## Manufacturer Declaration

### Additional hints for compensating disturbances in TouchDIM operation mode of QT*i* DALI ballasts

Fig. 1

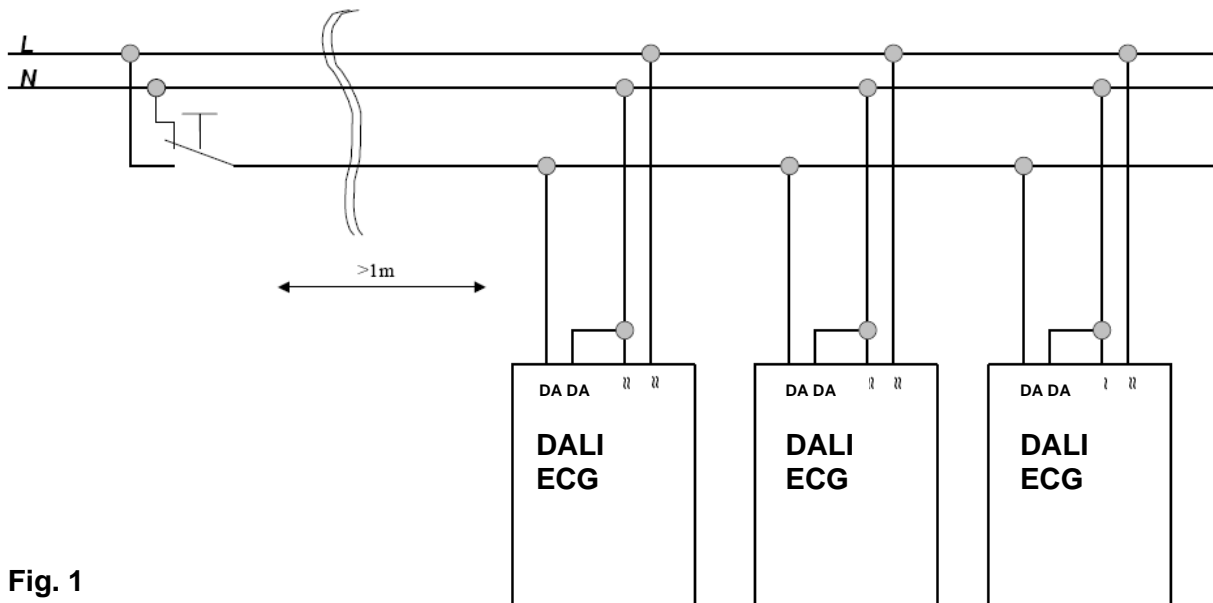
Using a Toggle Switch between Phase L and Neutral Line N (see Fig. 1) a connection of the two DALI lines can be realized in ECGs` Standby mode. As a result, no disturbance coupling effect is possible.

Fig. 2

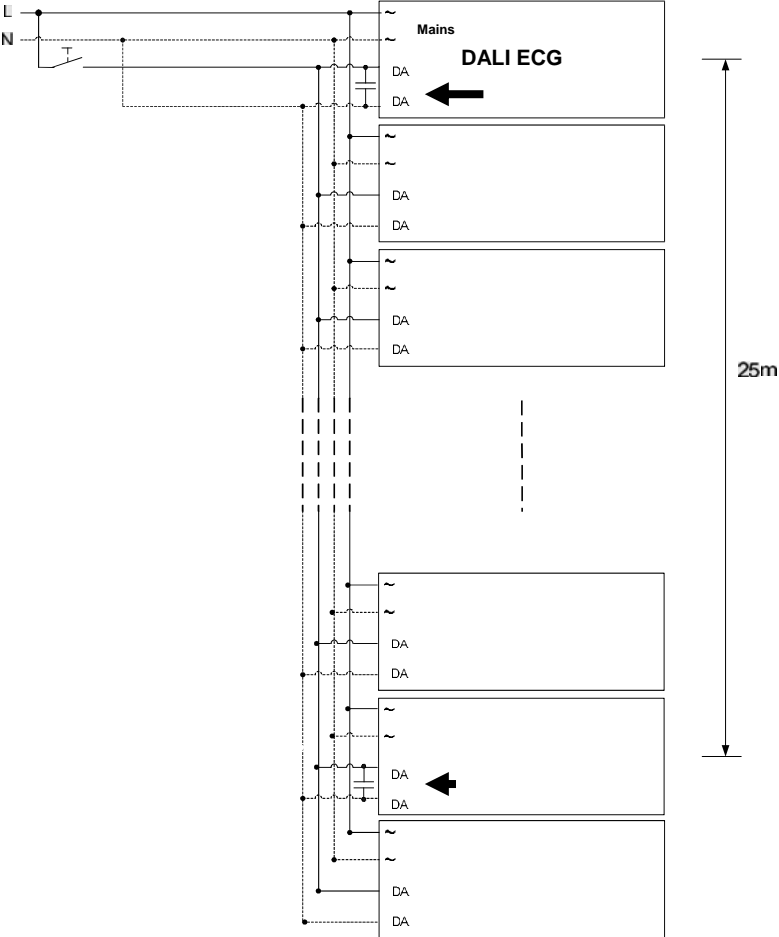
Using DALI line lengths > 25m leads to a capacitive compensation of at least 10nF/m line length (i.e. 300nF at 30m, 400nF at 40m etc.). That capacitive compensation (250V, X2 type) has to be installed in parallel to **one ECG`s DALI** interface. Another possibility is, to achieve the compensation via

parallel switching of capacitors being installed to several ECGs (total capacity has to be achieved, see Fig. 2).
